Alex Austin, an AQF level 8 Arborist, was commissioned by James McHugh, to respond to the Northern Beaches Council Landscape and Natural Environment Referral Responses for his proposed Development (DA2022/0196) at 17 Thompson St Scotland Island.

3. Natural Environment Referral Response – Biodiversity

4. Landscape Referral Response

Figure 1: Stage 1 Plan excerpt, (Source: Proposed Plans by Design Waves, Rev A, 21/09/21)

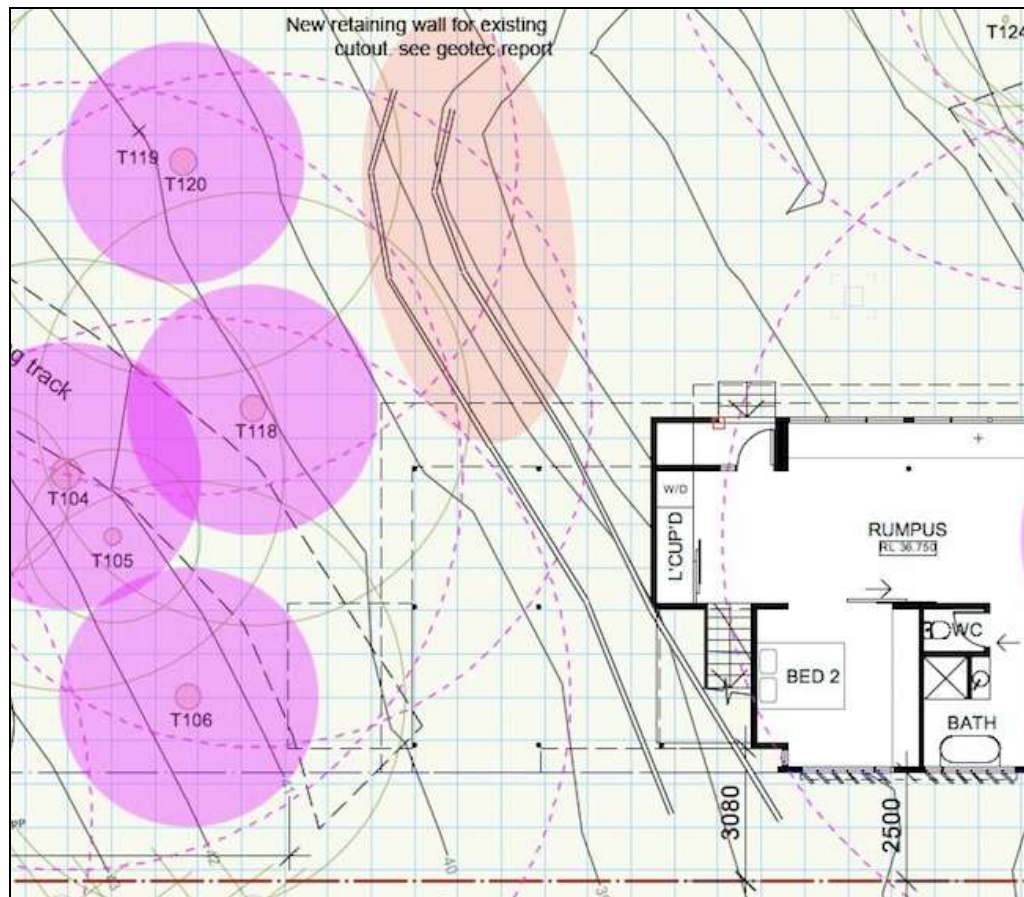
“Pier footing structural layout plans for the dwelling and home office shall be developed in co-ordination with an Arborist with AQF minimum Level 5 qualifications in arboriculture, and a qualified Structural Engineer, following a tree root mapping investigation near existing tree(s) identified in the Arboricultural Impact Assessment as tree numbers T104, T106, T118, T130 and T136 to locate critical tree roots and recommend pier footing locations for the construction of the dwelling and home office. The Arborist shall review, comment, recommend design revision as required and approve the pier footing layout, to ensure the locations of piers will be manageable in terms of tree protection measures.

A non-destructive root investigation shall be conducted complying with clause 3.3.4 of AS 4970-2009 Protection of Trees on Development Sites.

The Arborist shall submit certification to the Certifying Authority, that the locations of the pier and post footings are accepted. The agreed footing structural layout plans shall be submitted to the Certifying Authority for approval prior to the issue of a Construction Certificate”

The entire house is raised on piers and not touching the ground in the TPZ. The dwelling has been specifically situated so that no piers are located in the SRZ of any tree. Six(6) Pier holes are planned in the TPZ's of Trees T104, T106 & T118. It is only the pier holes that result in a loss of TPZ area. There may be some minor excavation under the house for clearance, outside the TPZ areas.

If the floating floor level was included, the TPZ encroachment calculation of the encroaching floor area within the TPZ is still considered minor as follows;

- T104 - 4%
- T106 - 11%
- T118 - 10%
- T130 - 10%
- T136 – 6%

As the Six (6) pier locations are outside the SRZ and take up <10% of the TPZ, In line with section 3.3.2 of AS 4970:2009, a <10% incursion to a TPZ is considered a minor encroachment. Any more than 10% is considered a major incursion and special measures should be taken to minimise impact on the retained trees and the Arborist must demonstrate that the tree will remain viable post construction. The pier holes do not take up more than 10% of TPZ area, therefore special measures such as root mapping do not need to be undertaken. See the following page for plan excerpts for further detail.
